**RE: Tract 3, Paradise Plaza
Grading Plan
Stamp Date: 6/23/17
Hydrology File: A11D012A**

Based upon the information provided in your submittal received 6/23/2017, the Grading Plan **is not** approved for Building Permit. The following comments need to be addressed for approval of the above referenced project:

sheet
CG-101

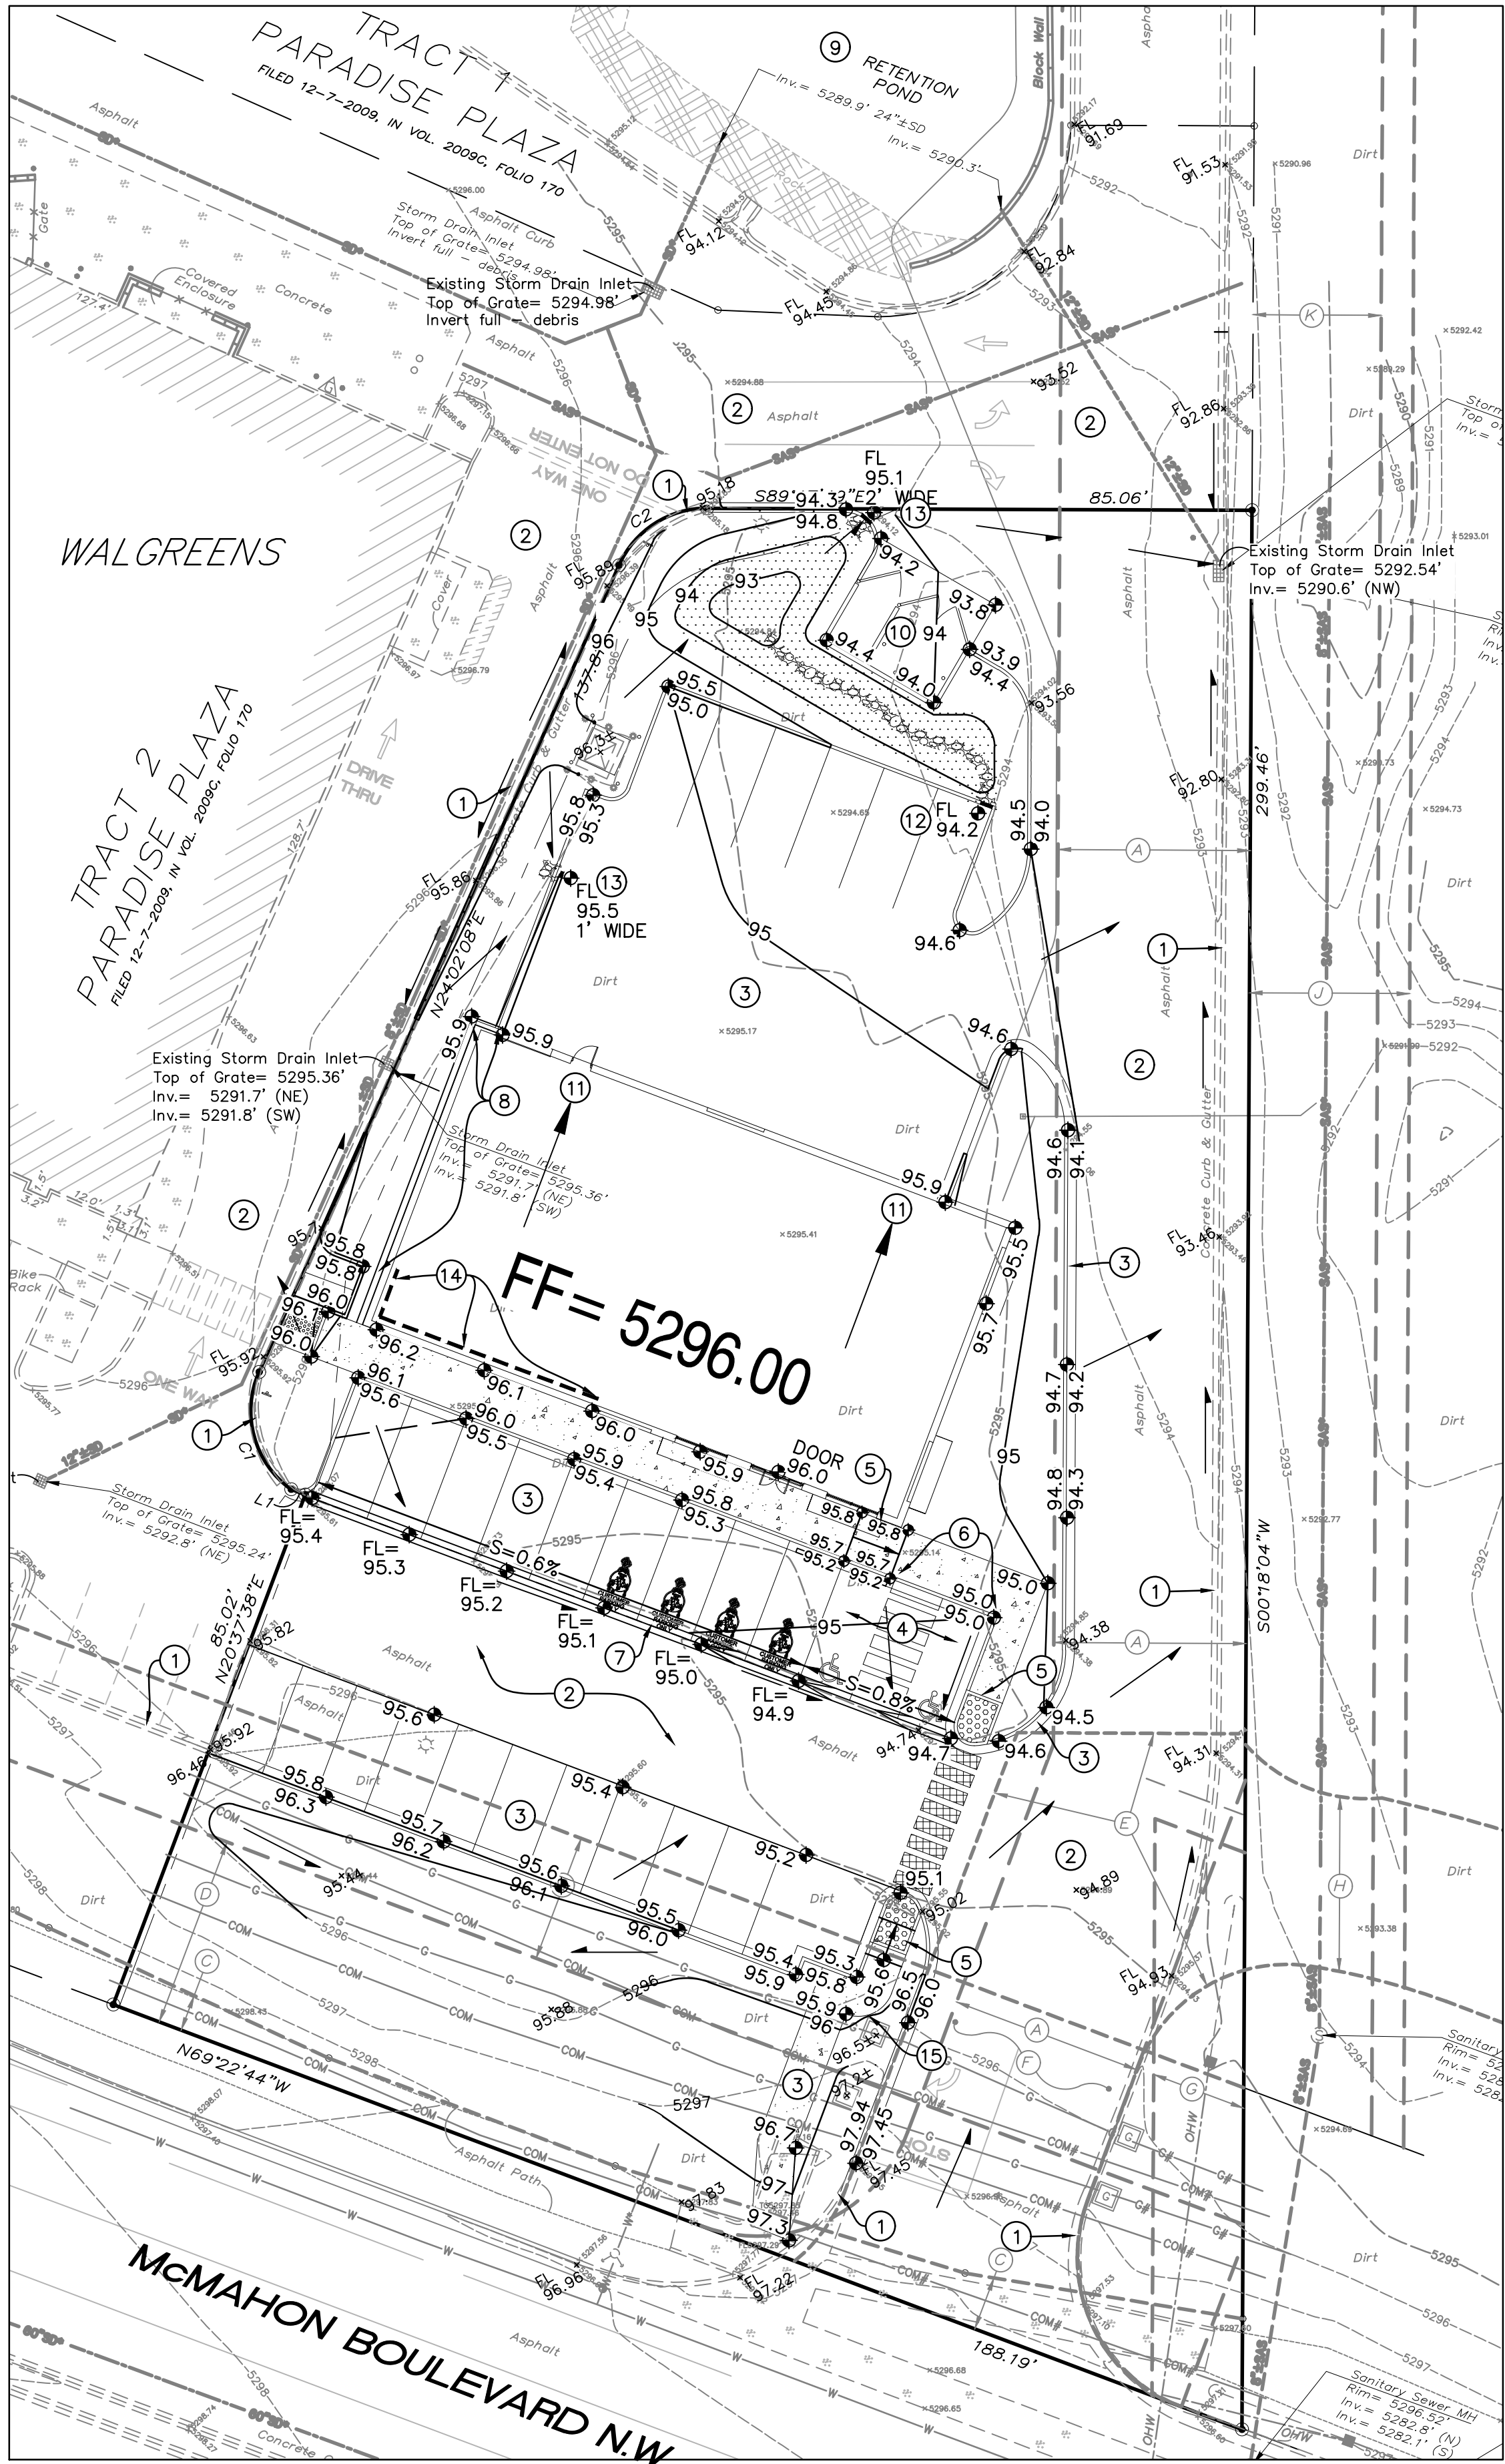
1. On Sheet CG-101. Please provide the water block on the existing drive near the existing retention/detention pond.

2. On Sheet CG-101 under the Drainage Plan Concept. Please state that this tract follows the Drainage Master Plan titled, Supplemental Drainage Information for Paradise Plaza (Tracts 1, 2, & 3) by Isaacson & Arfman dated 8/14/08.

3. On Sheet CG-101 under the First Flush Requirement. It mentions "see supplemental Information Packet". This was not submitted. If this is not going to be, then please remove the note. If this refers to the information noted in the above comment, then just change this note to read, " See Supplemental Drainage Information for Paradise Plaza (Tracts 1, 2, & 3) by Isaacson & Arfman dated 8/14/08".

CG-501

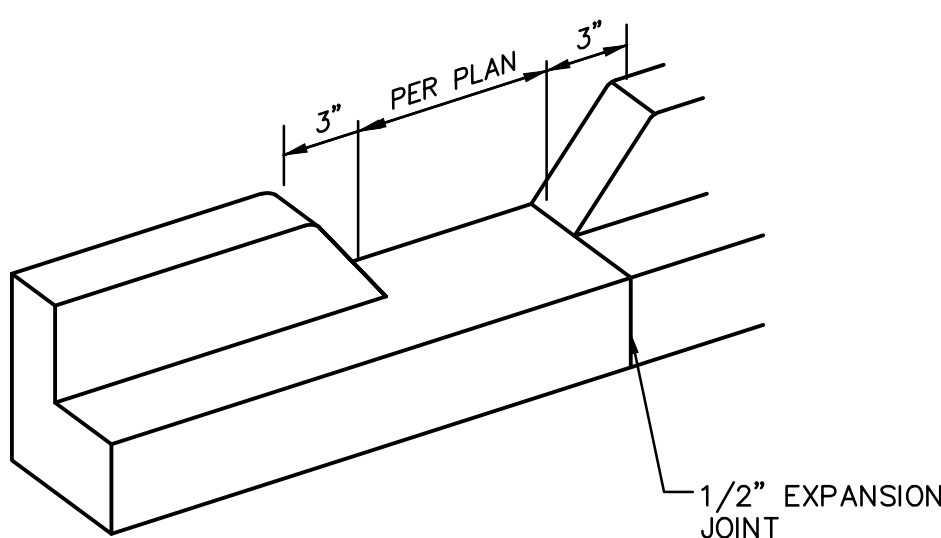
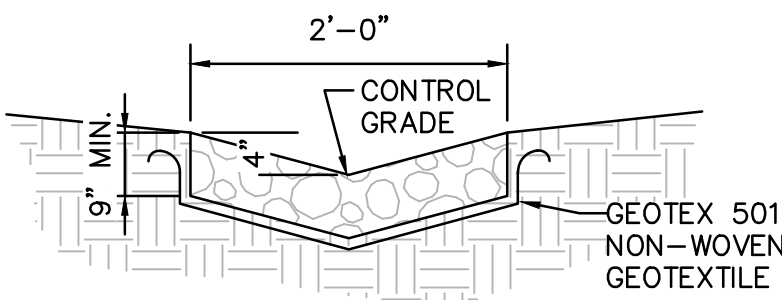
4. On Sheet CG-501. For Tract 3, the calculated Q for the 100 Year - 6 hour is 3.5 cfs. According to the Supplemental Drainage Information for Advance Auto (Tracts 1) by Isaacson & Arfman dated 4/26/16, the existing detention pond has the capacity to only handle 3.2 cfs from Tract 3. Please provide the calculations that will support the additional runoff from Tract 3 in the existing detention pond.

5. On Sheet CG-501. Please provide the weir calculations for both of the curb cuts for the first flush basin.
6. On Sheet CG-501. Please expand the viewport to include the existing retention/detention pond.
7. On Sheet CG-501. Please show the detention volumes provided for Tracts 1, 2, & 3 and then provide the total volume of the pond. This information should be in a table which points to the existing pond.
8. On Sheet CG-501. Please make a note that the first flush volume for Basin B will be handled within the existing retention/detention pond.
9. On Sheet CG-50 on the Rock Erosion Protection Detail. Please provide the Rock type and size in the detail.
